ADA Curb Ramp New Construction Inspection Form (Parallel)

NW Main

23885.56

NW Lenox

PARALLEL RAMP (PL)

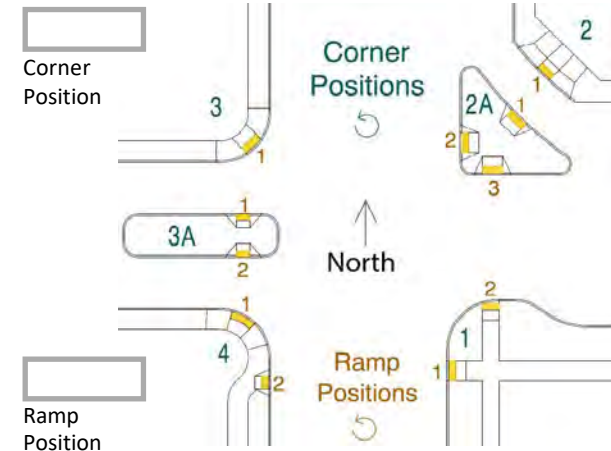
7.9 $\leq *$ ☐ $> *$ ☒

15.4 $\leq 8.3\%$ ☐ $> 8.3\%$ ☒

6.4 $\leq 2.0\%$ ☐ $> 2.0\%$ ☒

3.3 $\leq 2.0\%$ ☐ $> 2.0\%$ ☒

Comments:
DWS IITD Fails RR 1
